ADDENDUM NO. 1

April 14, 2022

YOST ELEMENTARY SCHOOL ADDITIONS AND RENOVATIONS Chesterton, IN 46304

Addendum One (AD.01) to the drawings and specifications prepared by Gibraltar Design for **New Yost Elementary School** for Duneland School Corporation, Chesterton, Indiana.

A-860 1/4" = 1'-0"

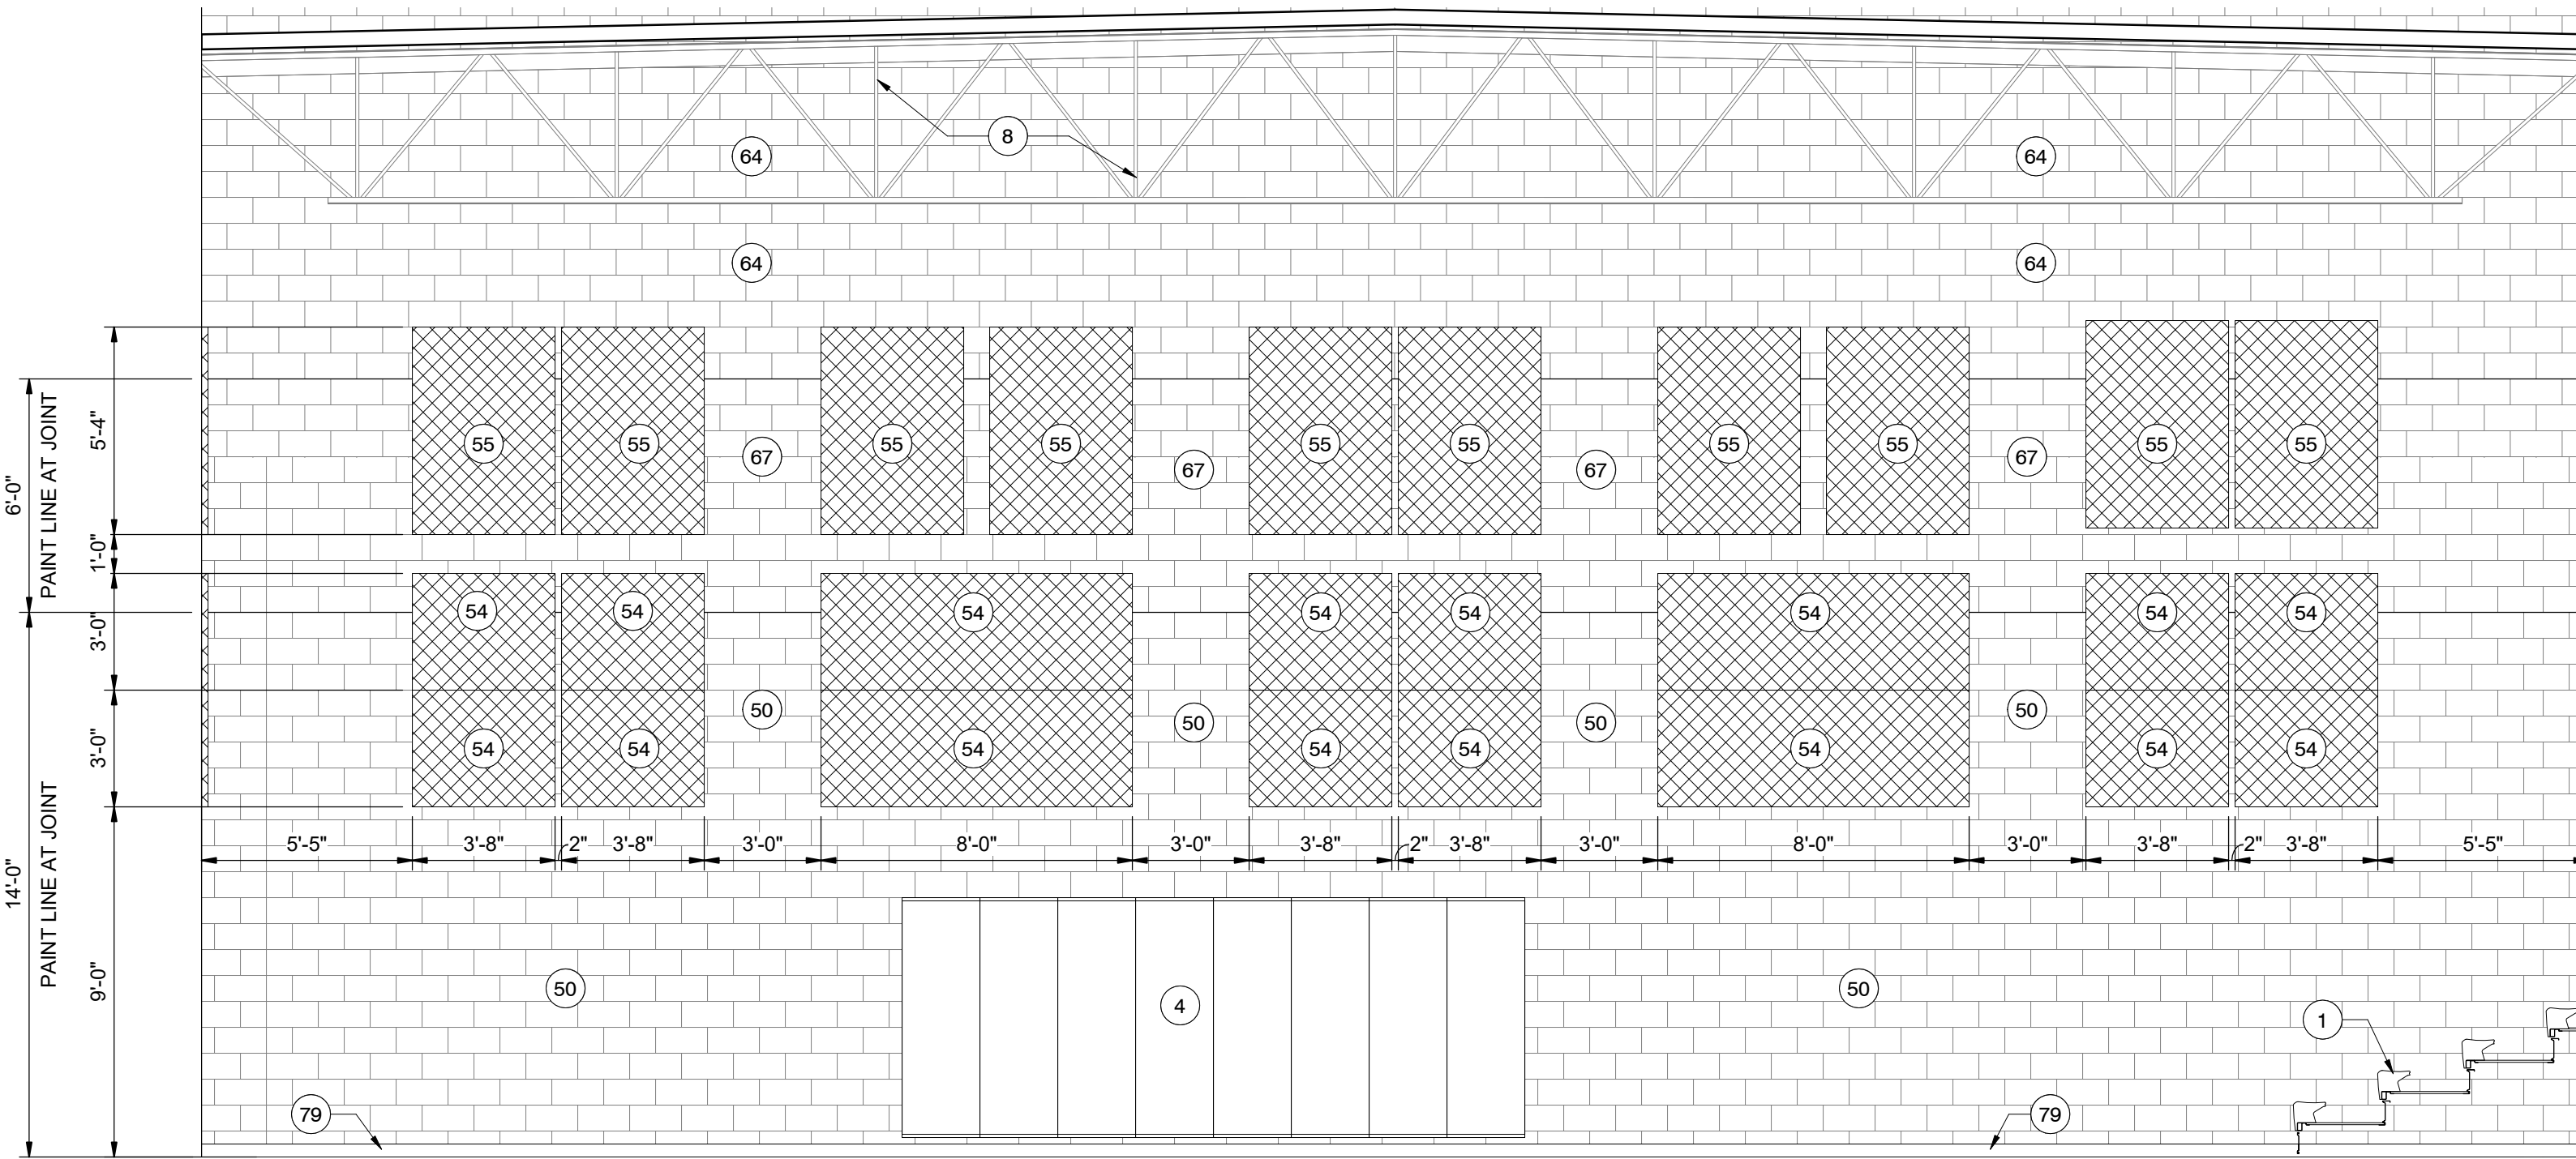
27. Sheet A-860

- A. Refer to revised full size drawing, included in this Addendum, for Interior Elevation Key Note #4 changed - Add "School Graphic TBD" to wainscot wall padding.

1
A-905 / 1/8" = 1'-0"

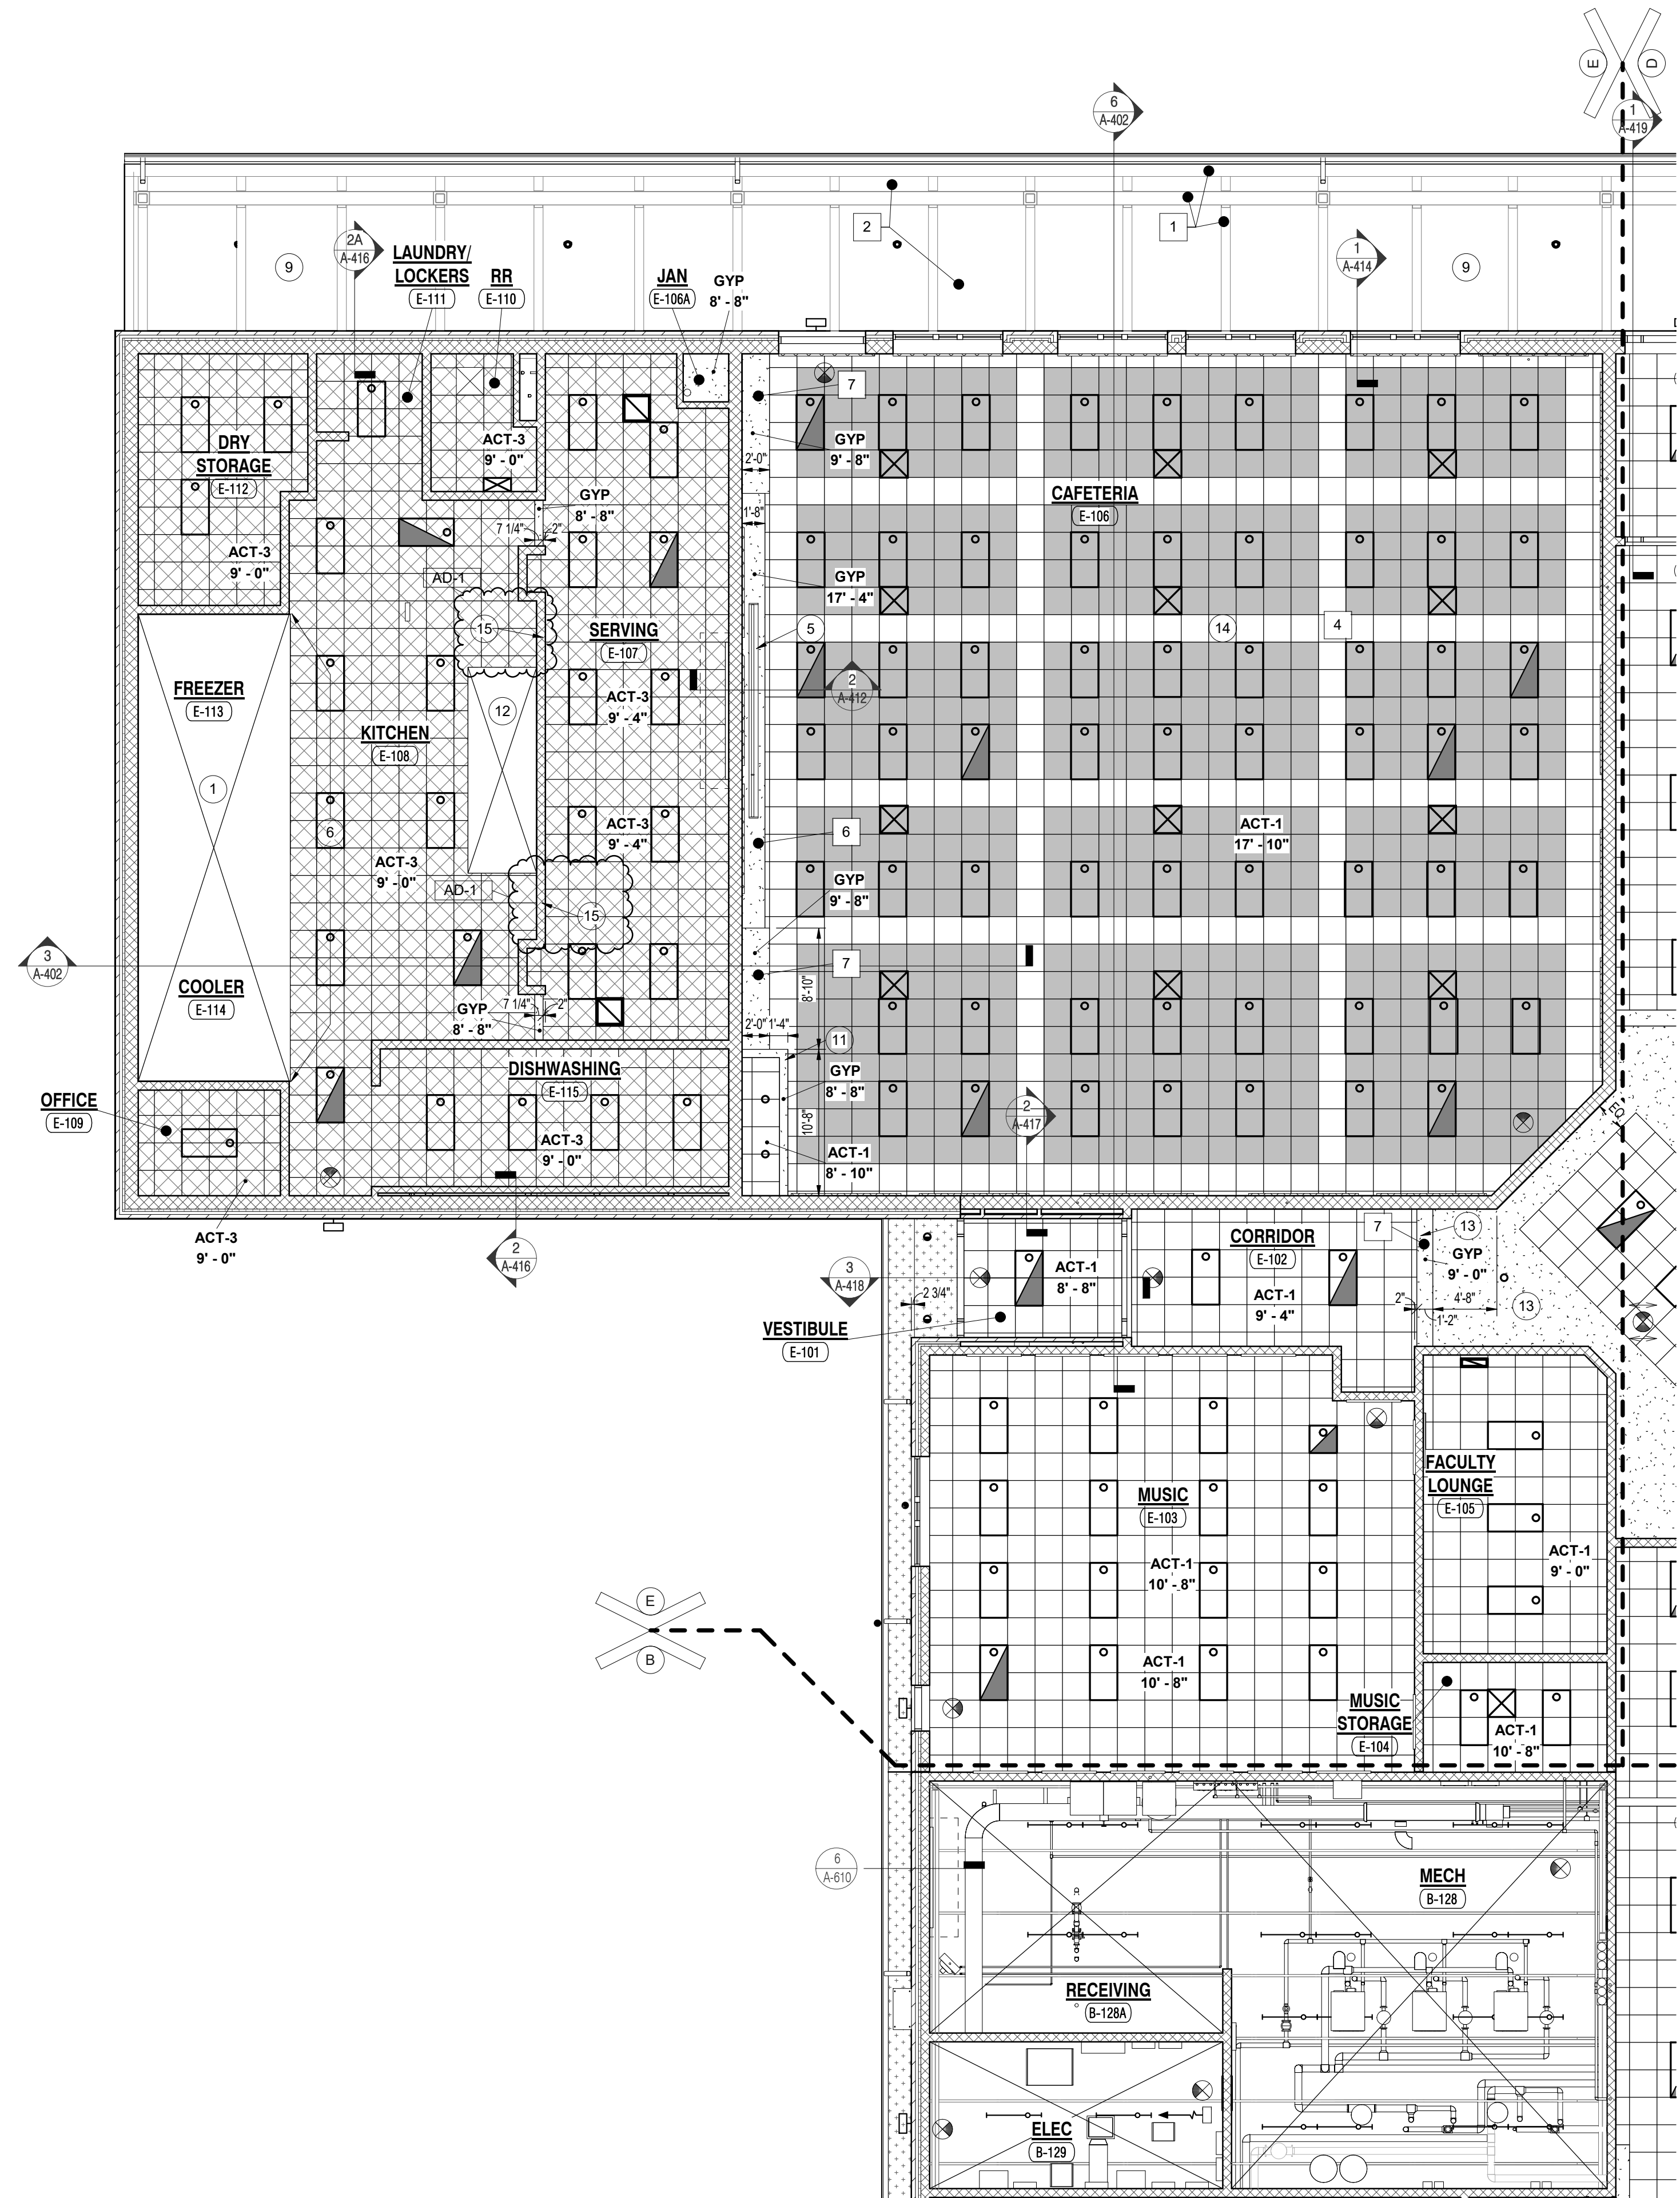
28. Sheet A-905

- A. Refer to revised full size drawing, included in this Addendum, for the following revisions:
 1. Add Key Note #15 to read "CMU Lintel at 107'-4"."
 2. Add note 15 in two locations on wall between Serving E-107 and Kitchen E-108.

E MV105

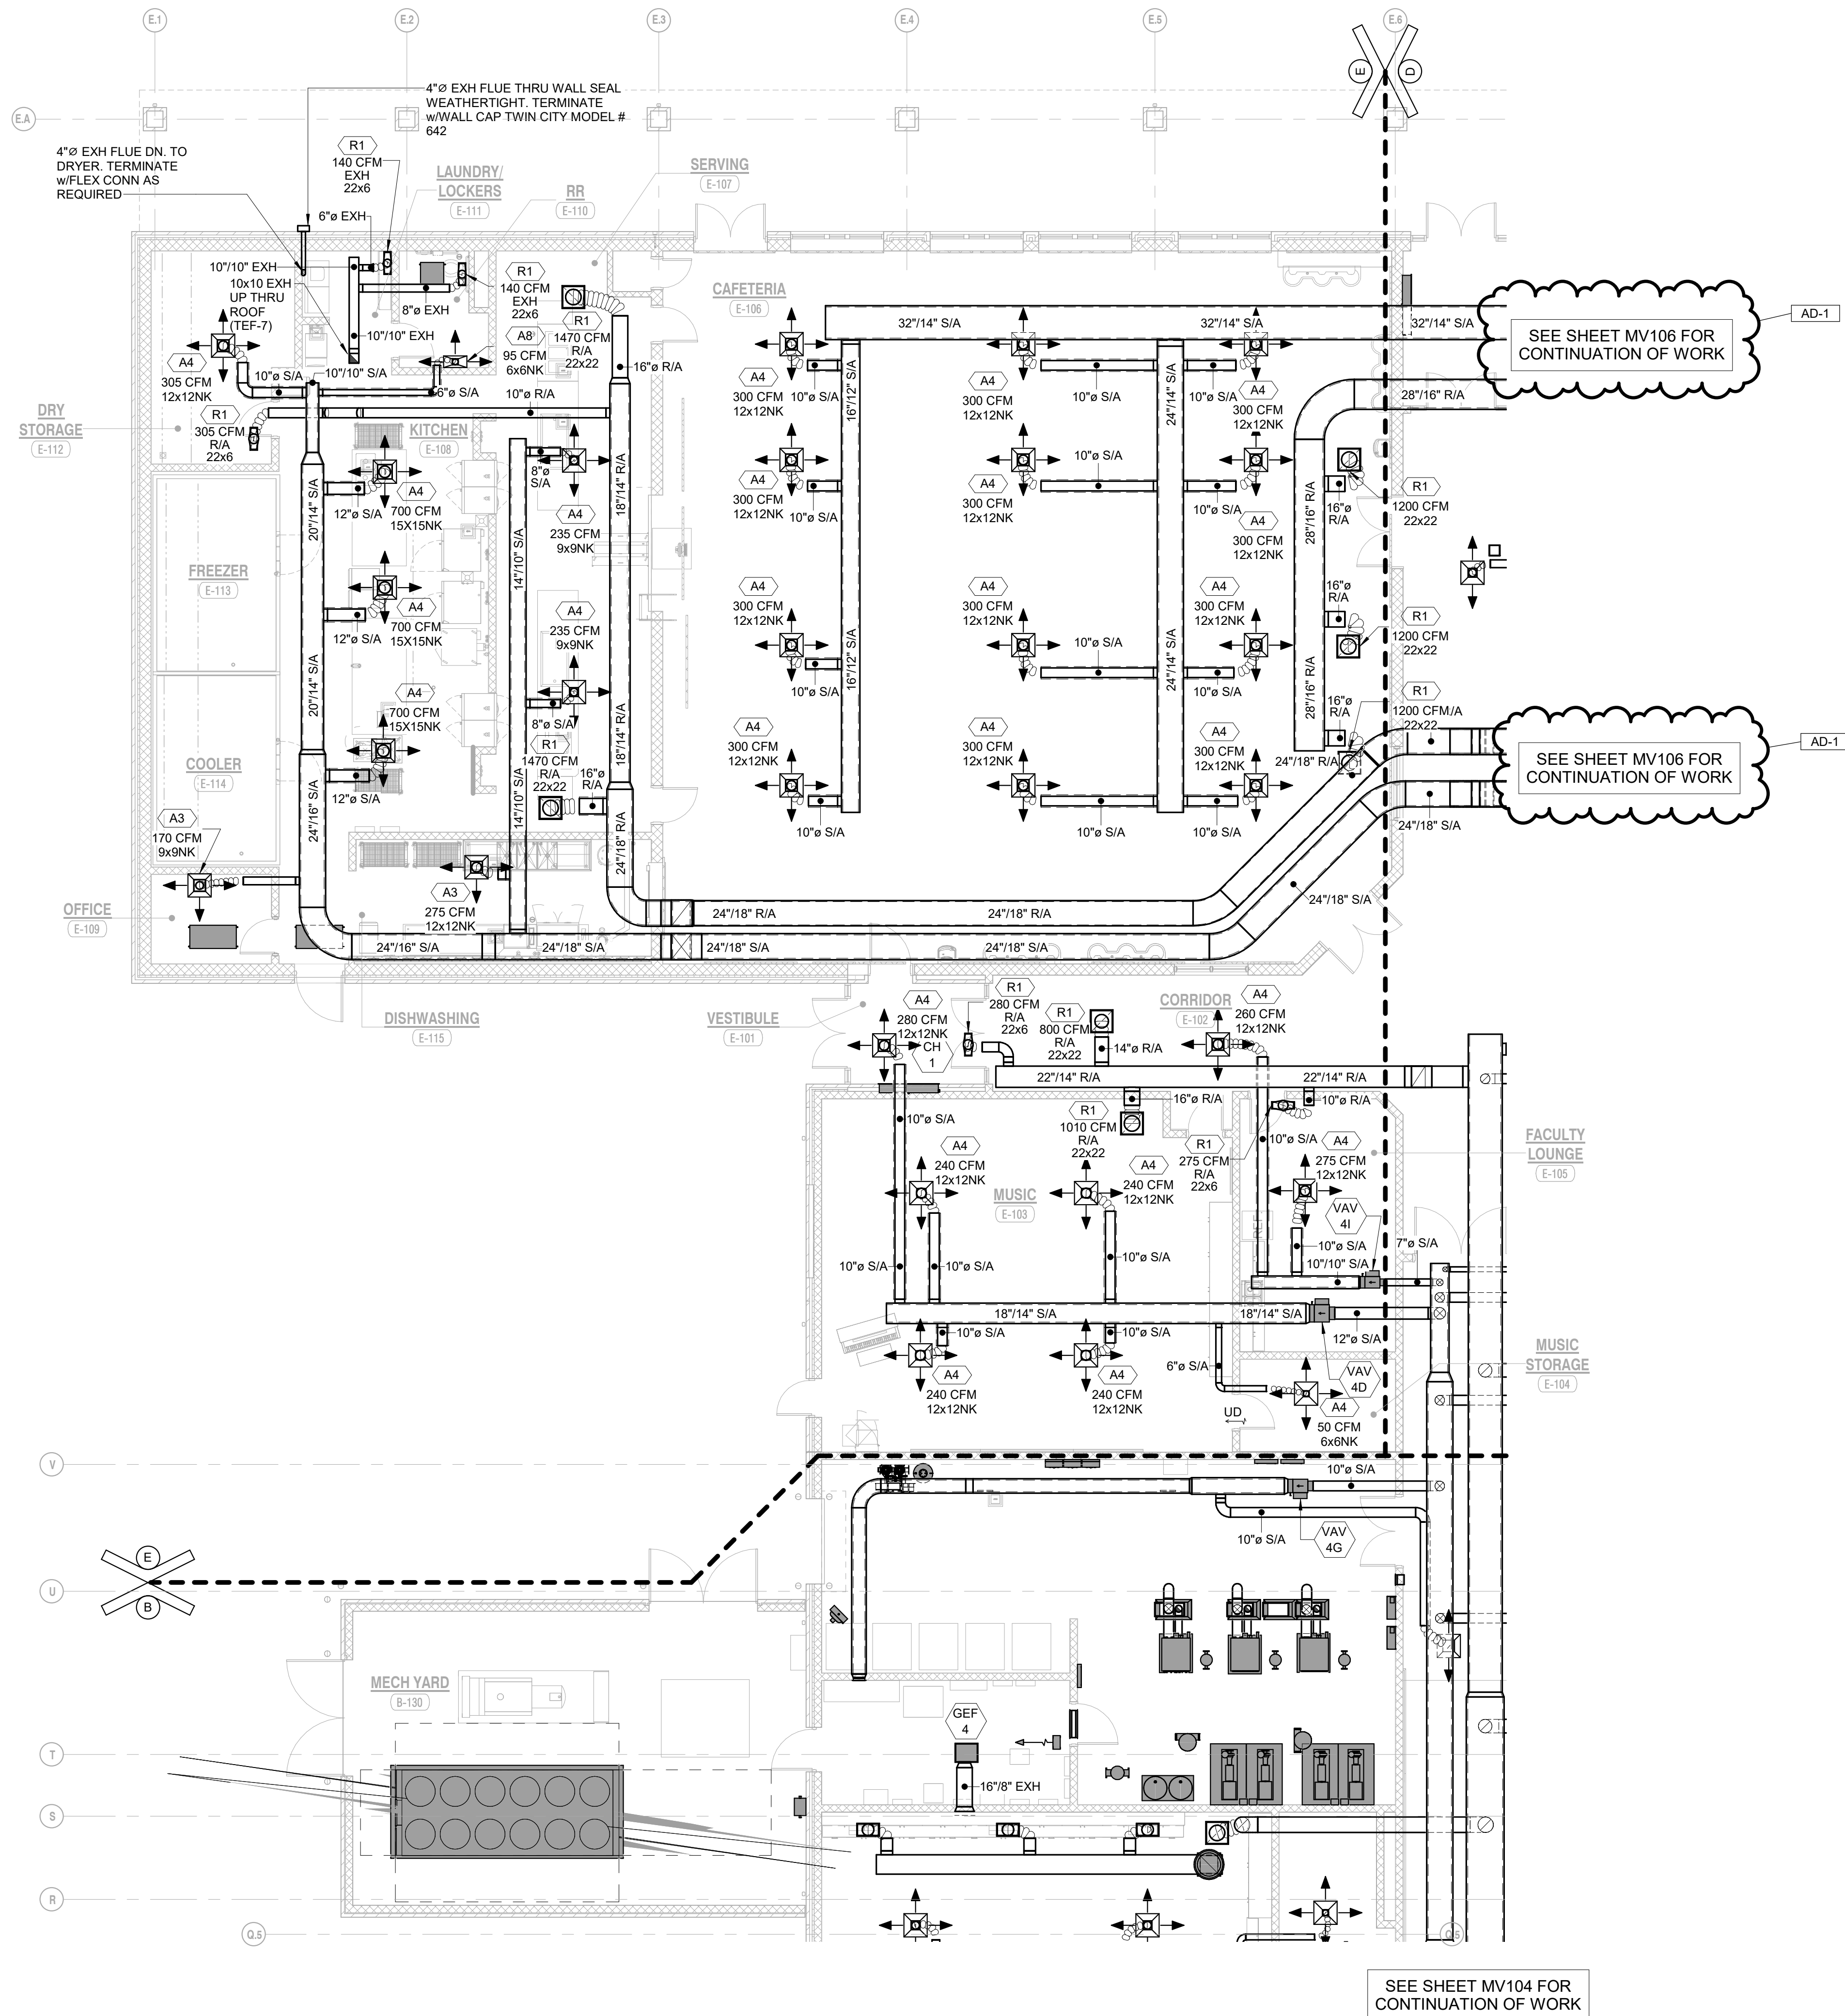
31. Sheet MV105

- A. Refer to revised full size drawing, included in this Addendum, for revised continuation note.
